**MEMORANDUM NO. 34-00:**

**SUBJECT: IMPLEMENTATION OF REVISED FRICTION COURSE LIMITS  
(ON SHOULDERS OF LIMITED ACCESS FACILITIES)**

**SUBJECT:** Implementation of Revised Friction Course Limits (on Shoulders of Limited Access Facilities)

SHOULDER DETAIL

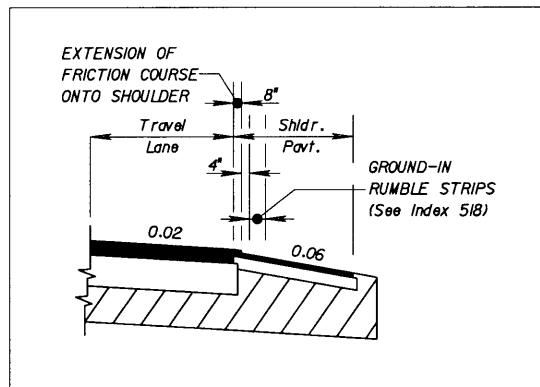
As a result of the request from Freddie Simmons on November 20, 2000, the Roadway Design Office has revised the *Roadway and Traffic Design Standards*, Index No. 518 (Rumble Strips, copy attached). This change involves a reduction in the distance between the rumble strip and the edge of the travel lane from 16 in. to 1 ft. To maintain the 4" clearance between the edge of the friction course and the rumble strip, the limits of friction course on limited access facility shoulders (Section 2.3.1, Plans Preparation Manual, Volume I) are being revised. The extension of the friction course onto the shoulder is being reduced from 1 ft. to 8 in. as shown in the figure below.

HALF PLAN  
 LIMITED ACCESS FACILITIES  
 SHOULDER GROUND-IN RUMBLE STRIP PLACEMENT

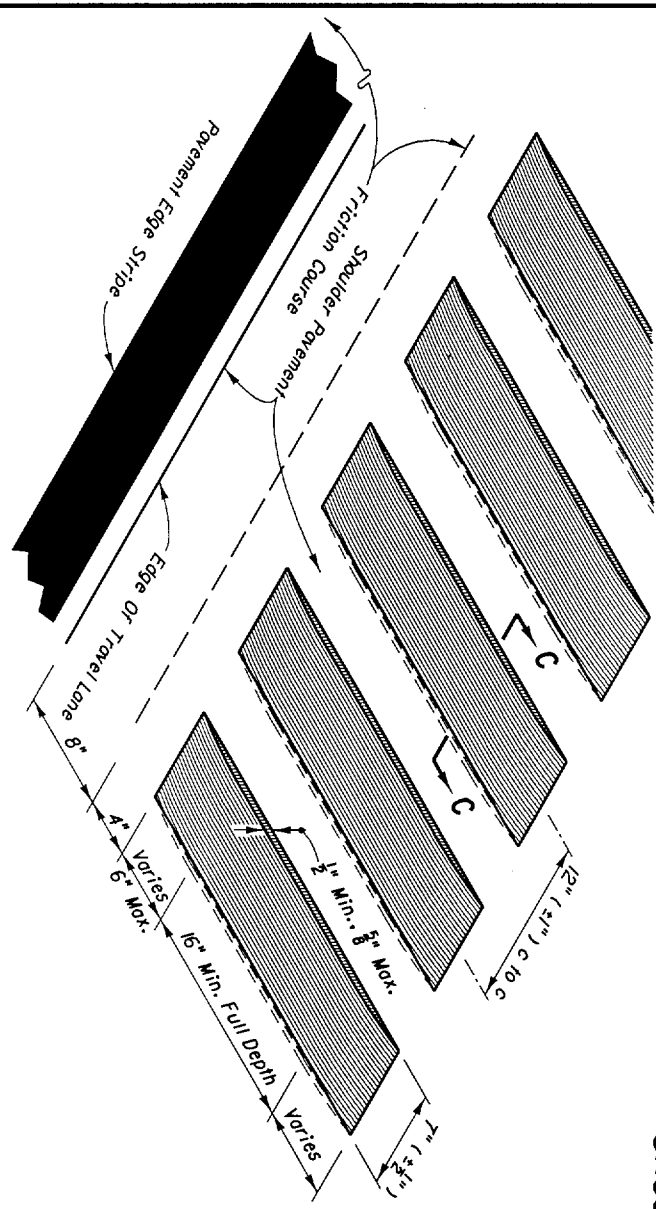
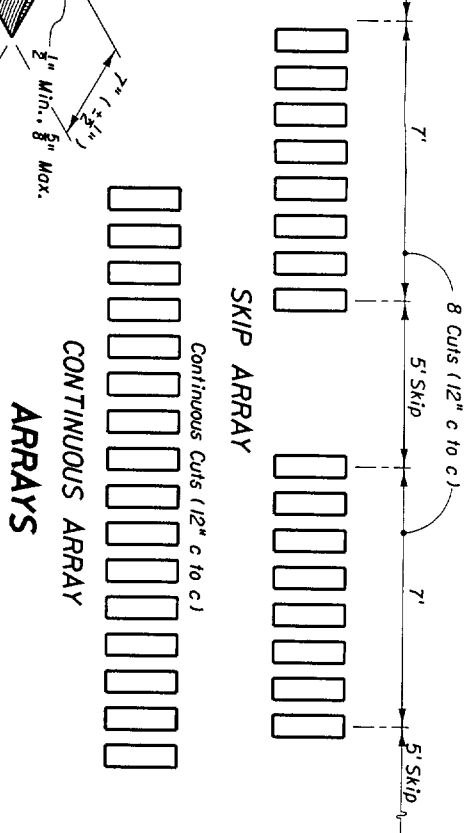
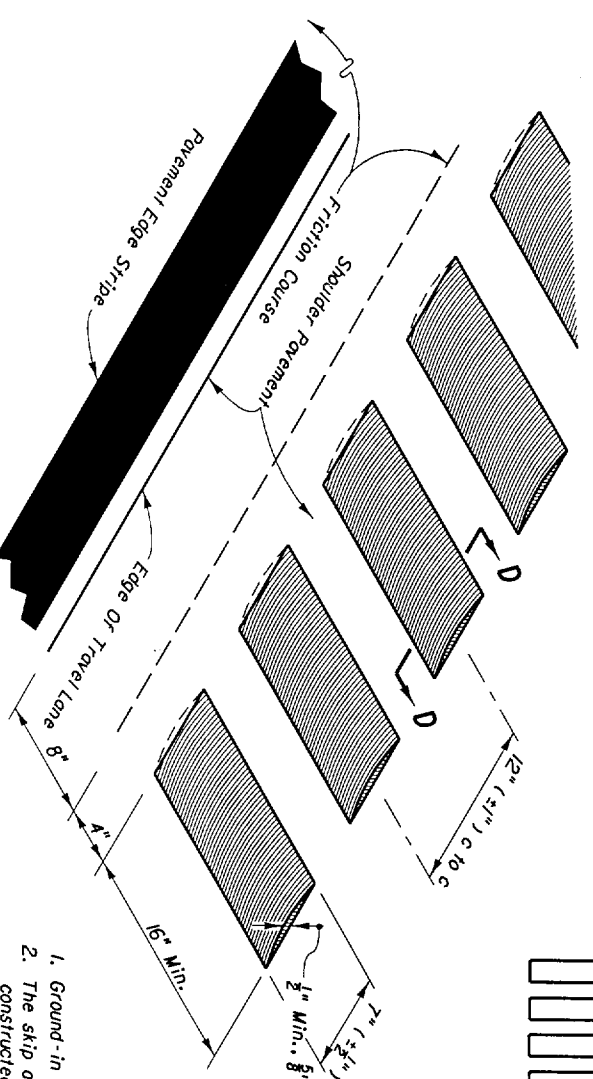
Effective immediately, please implement the change involved in reducing the distance between the rumble strip and the edge of the travel lane from 16 inches to 12 inches, as defined in Billy Hattaway's memorandum dated November 27, 2000 (see attached copy).

The extension of the friction course onto the shoulder is reduced from the current 1' to 8", resulting in 4" less friction course adjacent to each rumble strip. Please adjust friction course payment to reflect the decrease in friction course quantities.
